REPORT TO THE HEARING EXAMINER

HEARING DATE:	September 9, 2014
Project Name:	Renton Heritage Apartments
Owner:	Renton Heritage LLC; 11747 NE 1 st St #300; Bellevue, WA 98005
Applicant:	Oscar Del Moro, Cosmos Development Co. ; 11747 NE 1 st St #300; Bellevue, WA 98005
Contact:	Raymond Gamo, Stricker Cato Murphy Arch; 311 1 st Ave S #300; Seattle, WA 98104
File Number:	LUA14-000933, CU-H, SA-H, MOD
Project Manager:	Rocale Timmons; Senior Planner
Project Summary:	<p>The applicant is requesting Hearing Examiner Site Plan Review, Hearing Examiner Conditional Use Permit and a refuse and recycle modification for the construction of a 5-story mixed-use building containing 101 residential units and 3,553 square feet of commercial space. In 2008 the applicant received Hearing Examiner Site Plan, Conditional Use Permit, and parking modification approvals along with Environmental Review for the construction of a similar 101 unit mixed use building. However, the Hearing Examiner Site Plan, Conditional Use Permit expired in 2010. The applicant is now proposing to maintain much of the original proposal in order to eliminate the need for additional Environmental Review. The mixed-use structure wo

EXHIBIT 2

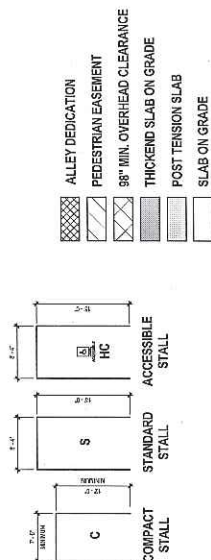
Therefore, staff recommends the applicant be required to revise the parking plan to include the following: relocation of the three northern most stalls located at grade along the alley and/or limit

the stalls to back in parking only; the provision of adequate ADA accessible parking stalls; and the provision of additional on-site stalls for potential residential/restaurant employees and restaurant patrons in the amount of 10-20 stalls. Alternatively, the applicant may provide parking off-site which could be subject to a joint parking requirement. The revised parking plan shall be submitted to and approved by the Current Planning Project Manager prior to building permit approval or construction permit approval whichever comes first.

4. The applicant shall be required to revise the parking plan to include the following: relocation of the three northern most stalls located at grade along the alley and/or limit the stalls to back in parking only; the provision of adequate ADA accessible parking stalls; and the provision of additional on-site stalls for potential residential/restaurant employees and restaurant patrons in the amount of 10-20 stalls. The plan shall include additional direct access stalls, in combination with tandem spaces (if utilized). Alternatively, the applicant may provide parking off-site which could be subject to a joint parking requirement. The revised parking plan shall be submitted to and approved by the Current Planning Project Manager prior to building permit approval or construction permit approval whichever comes first.

9. The applicant shall be required to provide bollards or an alternative measure to reduce the potential for vehicles to compromise the safety of patrons using the proposed outdoor seating area. The revised site plan shall be submitted to, and approved by, the Current Planning Project Manager prior to building permit approval.

EXHIBIT 5

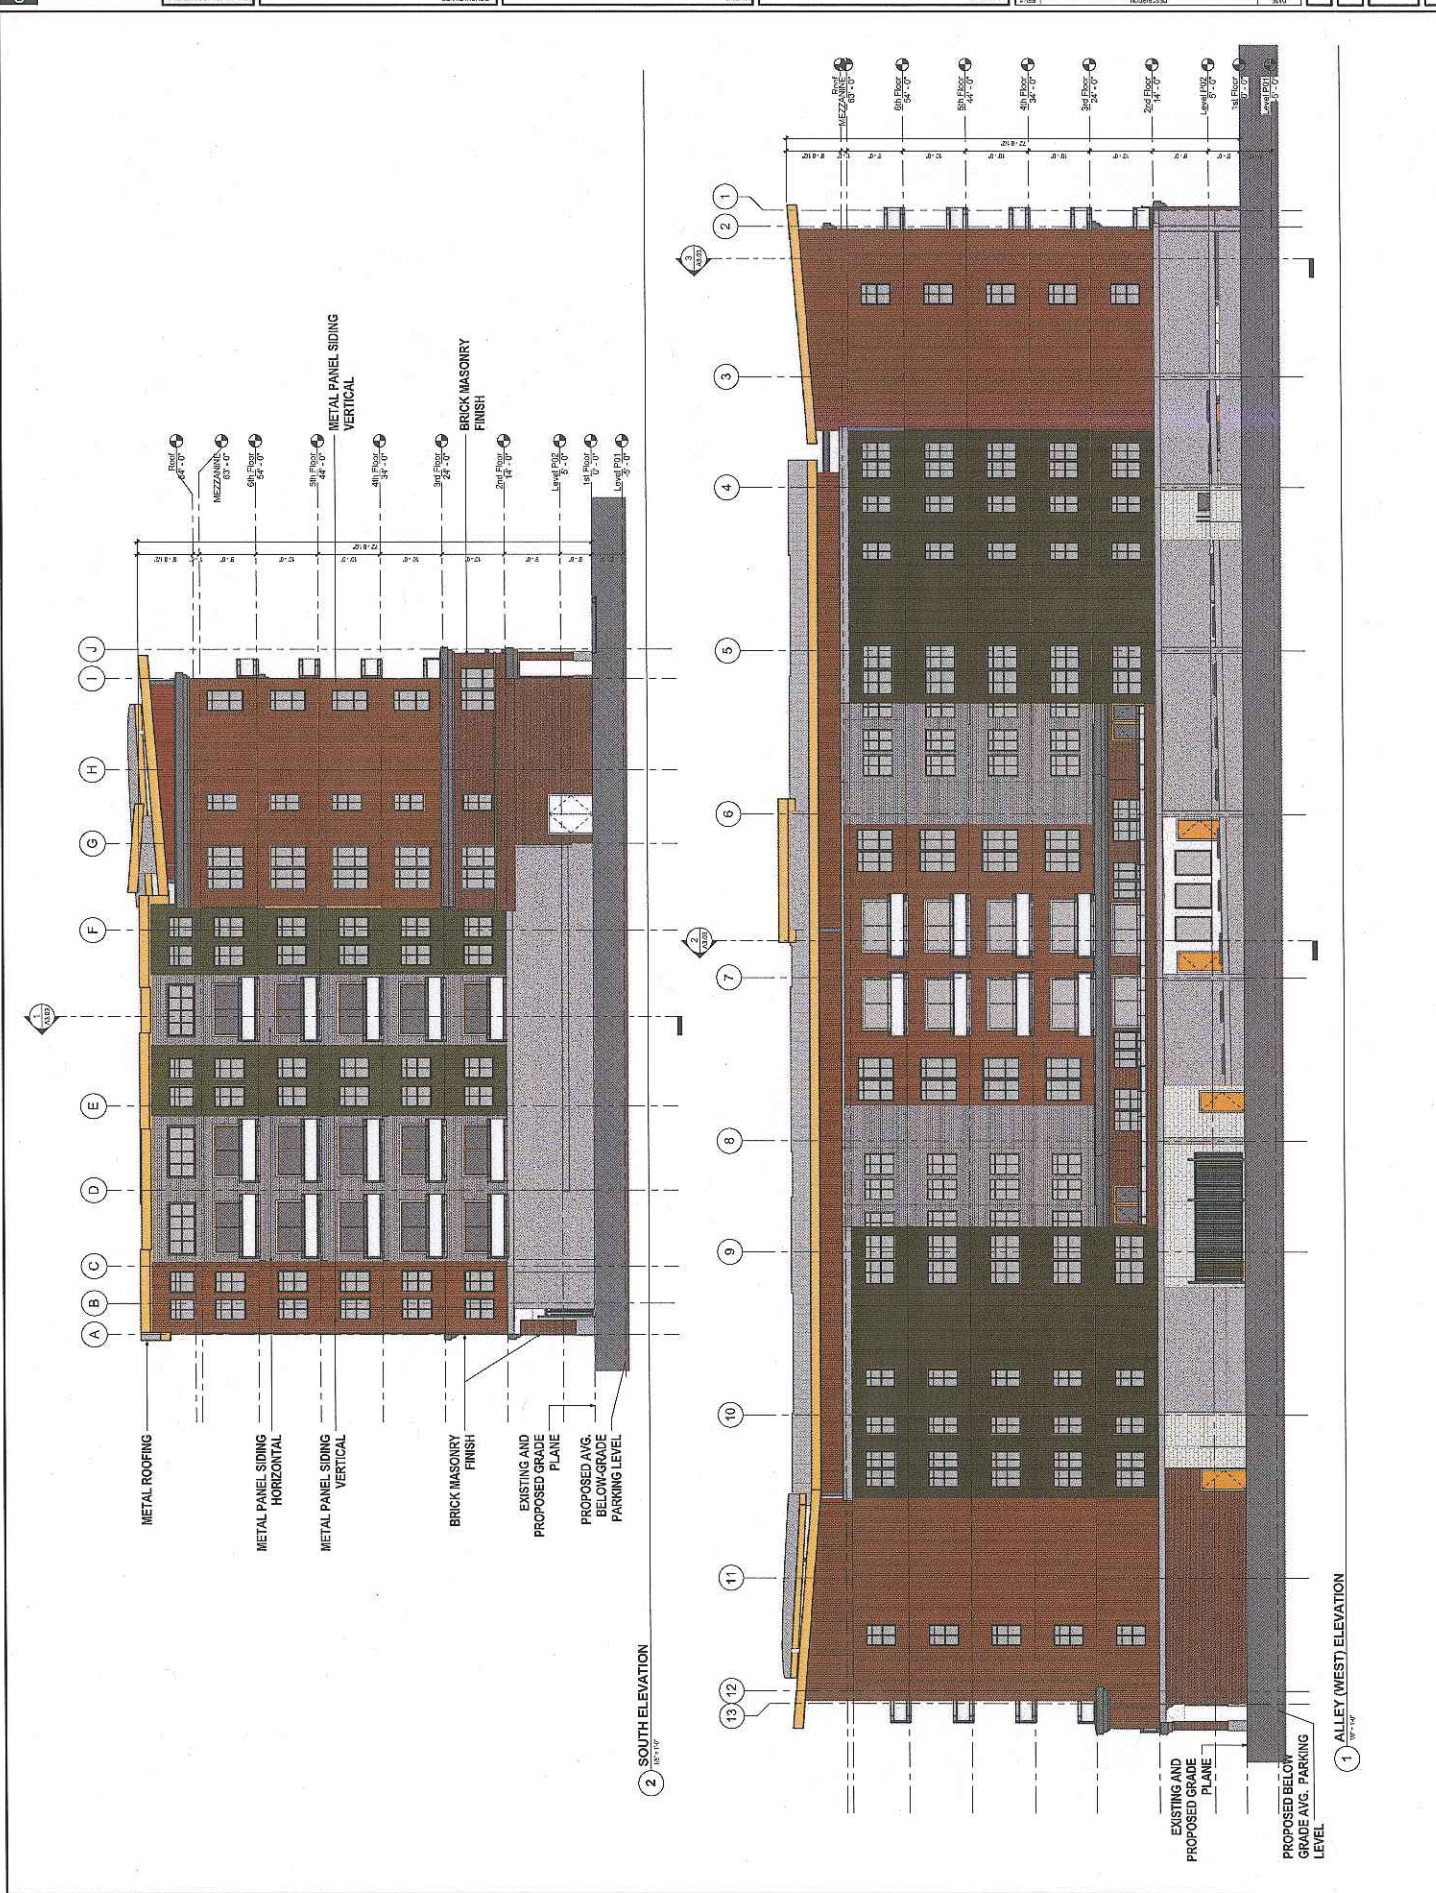
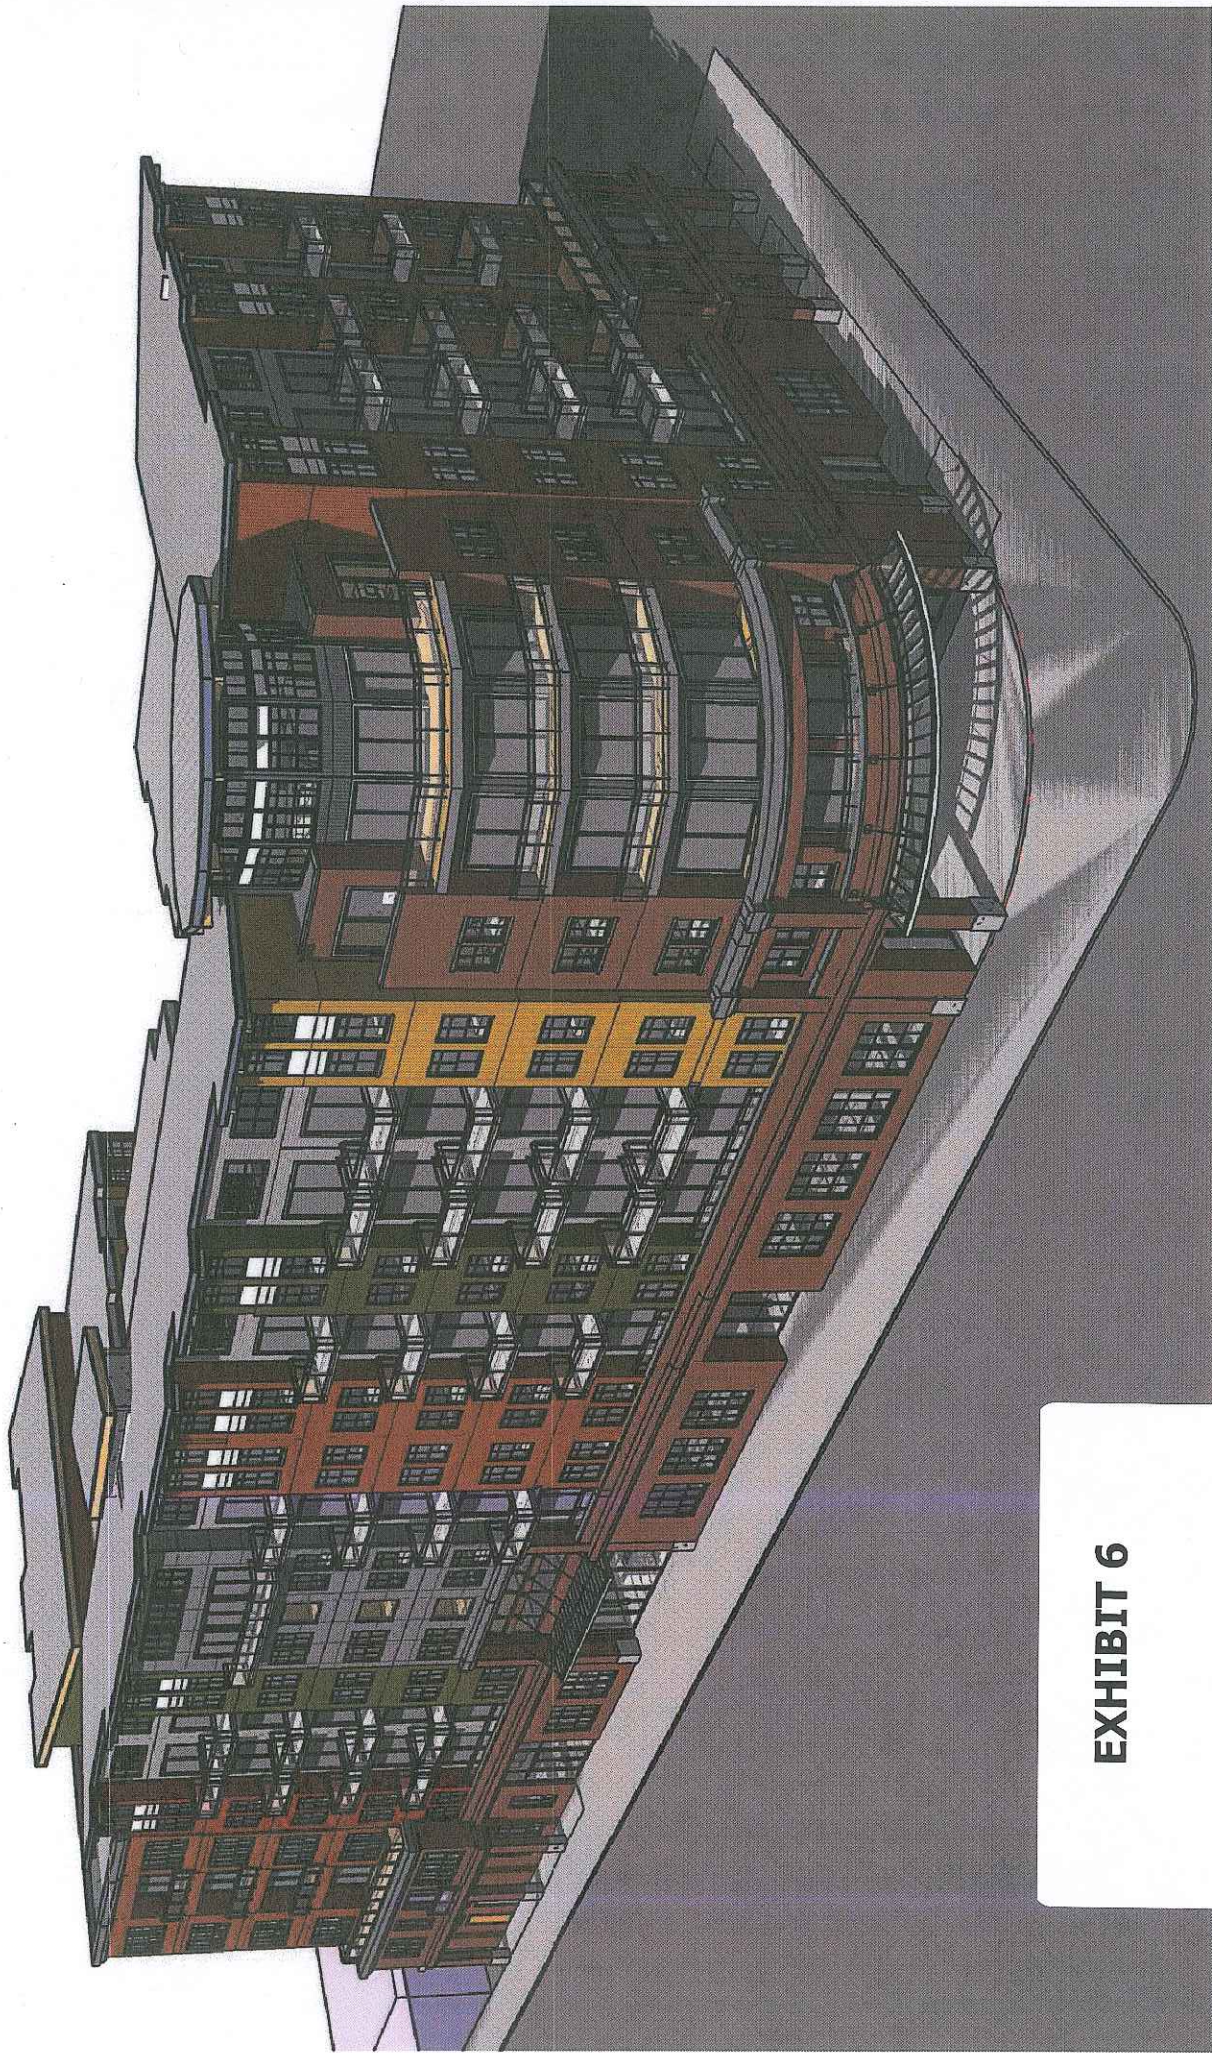
10. The proposed structure would be 72 feet and 8 ½ -inches from the existing (and proposed) grade plane, at the tallest point of the shed roof elements (Exhibit 5).

13. Cement board paneling of various colors and horizontal and vertical metal siding is proposed for use in order to create visual interest and provide breaks in exterior walls (Exhibit 5).

<p>design and the use of a two-story entrance at the corner.</p> <p>Therefore, staff recommends as a condition of approval the applicant submit revised elevations which incorporate additional height for the first story of the entire structure, to no less than 15-feet, and the use of a two-story entrance for the commercial component at the corner of Main Ave S and S 2nd St. The applicant may also submit an alternative solution which would provide additional natural light to the commercial use (both indoor and outdoor) and achieves a more prominent architectural entrance at the corner of Main Ave S and S 2nd St. The revised elevations shall be submitted to, and approved by, the Current Planning Project Manager prior to building permit approval.</p> <p>Staff will also be recommending the use of floor to ceiling windows for the commercial component of the project, as part of the glazing discussion below, which would also serve to enhance the natural light availability for the commercial use.</p> <p>The proposal is well beneath the maximum horizontal surface height limit of 179 feet above mean sea level and therefore the recommended increases in height would not impact the proposals ability to comply with the maximum height limit.</p>

7. The applicant shall submit revised elevations which incorporate additional height for the first story of the entire structure, to no less than 15-feet, and the use of a two-story entrance for the commercial

component at the corner of Main Ave S and S 2nd St. The applicant may also submit an alternative solution which would provide additional natural light to the commercial use (both indoor and outdoor) and achieves a more prominent architectural entrance at the corner of Main Ave S and S 2nd St. The revised elevations shall be submitted to, and approved by, the Current Planning Project Manager prior to building permit approval.

11. The applicant shall submit revised elevations depicting added floor to ceiling window types for the extension of the proposed retail space to the west along S 2nd St and south along Main Ave S to the respective retail space entrance from the sidewalk. The revised elevations shall be submitted to and approved by the Current Planning Project Manager prior to building permit approval.
